GLASTAR SERVICE BULLETIN 48

Mandatory

Subject: Elevator Bellcrank Clearance Inspection and Aileron Inspection Provisions.

Applicability: All GlaStar kits

Figure 2. Modified Elevator Bellcrank Installation for Improved Clearances

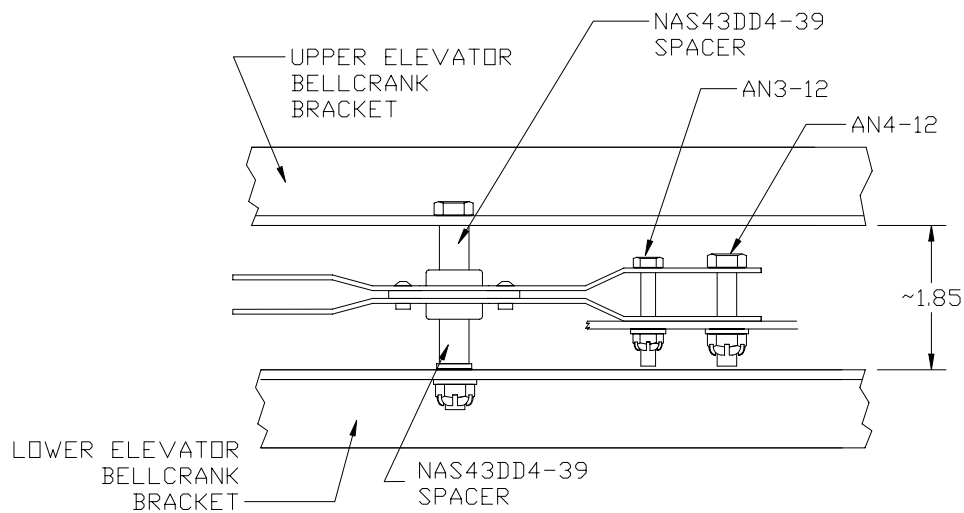
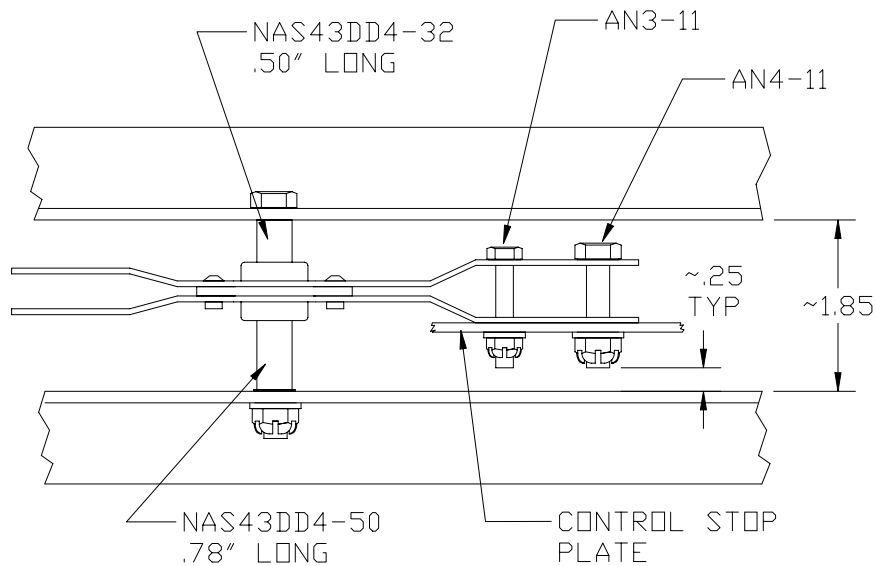
As the elevator bellcrank moves through its range of motion for controlling the elevator, adequate clearance should be maintained at all times between all moving parts to avoid potential interference and binding of the control system. When the builder first installs the upper and lower bellcrank brackets in the fuselage as prescribed in Figure 85 of Section VIII, the Assembly Manual does not give a controlling dimension, but rather just says to use the “clamped up assembly”. If the brackets are installed properly and parallel to each other, the distance between the upper and lower brackets should be approximately 1.85 inches as shown in Figure 1 below. Since the two NAS43DD4 spacers are of equal length, the bellcrank assembly is centered between the two brackets. But when the control cable, elevator stop and elevator pushrod hardware is installed, the clearance at the bottom of the two bolts shown in Figure 1 is marginal or inadequate.

Figure 2 below gives a more optimum arrangement when installing the bellcrank assembly between the upper and lower brackets. By using unequal NAS43DD4 spacer lengths, the bellcrank assembly can be shifted up providing more clearance to the bottom of the bolts. By going to AN3-11 and AN4-11 bolts, additional clearance can be gained and still have adequate grip length for the bolts through the bellcrank assembly and the control stop. The builder should aim for .25 inches of clearance between the bolts and the bellcrank brackets. We have observed that the elevator pushrod attach bolts on the bellcrank assembly tend to deflect marginally up under a positive or tail down load (approximately .05”). Therefore, slightly more clearance should be provided between the head of the bolt and the upper bracket.

For those airplanes that are already flying or which have all the control rigging done and the tail section closed out, the primary importance is an inspection of the system as you have installed it. Remove the lower fuselage inspection cover and with a mirror and adequate lighting, move the elevator controls through its range of motion and measure the clearances between the upper and lower ends of the three bolts on the bellcrank. **The minimum recommended clearance on the lower edge of the bolt should be approximately 3/16 inch.** If you find your clearance is less than the minimum, you can gain 1/8 inch by switching the bolts over to an AN4-11 and an AN3-11 from the AN4-12 and AN3-12 as specified in the assembly manual. If you need additional clearance, then use the NAS43DD4 spacers specified in Figure 2. **Before you attempt to replace any hardware, the cable tension will have to be released on the elevator control cables.**

The NAS43DD4 Bolt Spacers can be made from 6061-T6 or 2024-T4 aluminum with an outside diameter of .38 - .50 inch. The bare material should be primed for corrosion protection. A Service Bulletin Kit **P/N GSSB48KIT-1** is available through Newglasair, LLC for \$11.99. This kit includes two new NAS43DD4 bolt spacers and the AN3-11 and AN4-11 bolts.

Figure 3. Small Inboard Cove Skin Cover Template

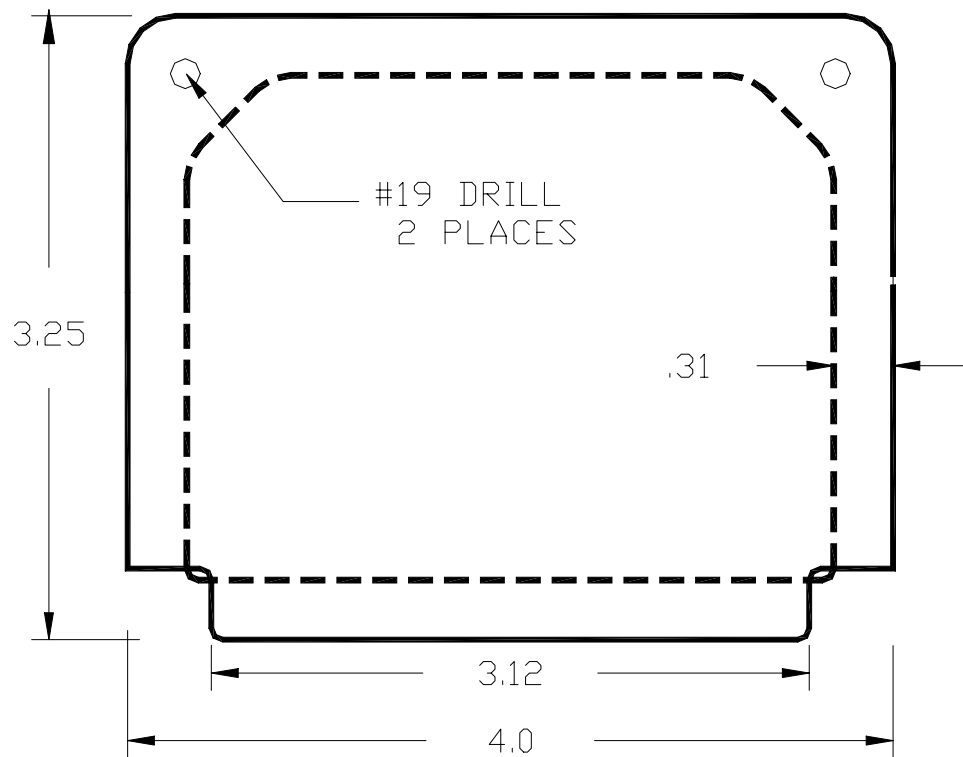
The flat pattern for the cover plates can be seen in Figures 3 and 4 below. The dashed line inside the perimeter is the profile of the access hole itself. (Do not cut this into the cover!) Use this template or cover when cutting the hole in the cove skin. Make sure you keep adequate edge margin for the two nut clips and number 8 screws that will hold the small cover down. The larger cover will use four screws and four nut clips each. The lower lip of the small cover is trimmed and joggled slightly to fit on the inside of the hole cut into the cove skin. The cove skins themselves are made from .016 thick aluminum skin. The covers could be made from .016, .020 or .025 aluminum. If you do not have any scrap material around to produce these covers yourself, a Service Bulletin Kit **P/N GSSB48KIT-2** can be purchased from Newglasair for \$14.99. This kit includes sheet material for covers, screws and nut clips for four access panels.

Figure 5. Position of Access Cover in Flap Cove Skin

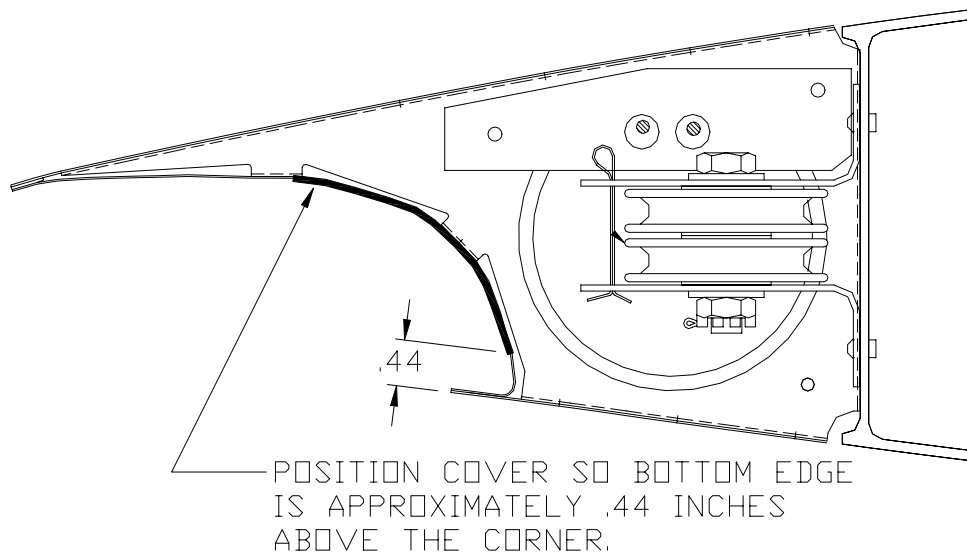
When positioning the cover to the cove skin, place the bottom edge approximately .44 inches up from the corner as shown in Figure 5. Your corner fillet on the cove skin might vary slightly, so position the cover where **you** deem the best fit to access the pulleys or fairleads. Mark everything out with a felt tip marker first and make sure it will all work as planned. When you are ready to cut the actual access hole in the cove skin make sure you are only cutting the hole to the size shown by the dashed line on the cover template shown in Figure 3 and 4. Round the corners and position and or trim for the nut clips until the holes line up with the cover. (These are a 3/8 inch throat nut clip, so keep your edge margin 3/8 inch) The recommended position for the **outboard edge** of the outboard cover plate is one inch inboard of the flap/aileron cove transition or 109.50 inches from root of wing. The recommended position for the **outboard edge** of the smaller inboard cover plate is 44.5 inches outboard from the root of the wing. Deburr all sharp edges and clean up the aluminum shavings if you are working in a wing with the cove skins already installed.

Finally install the P/N 450-0211-081 Nut clips over the cove skin. Then secure each Cover Plate over the hole with AN526-8R6 Truss Head screws or equivalent ones of your choice.
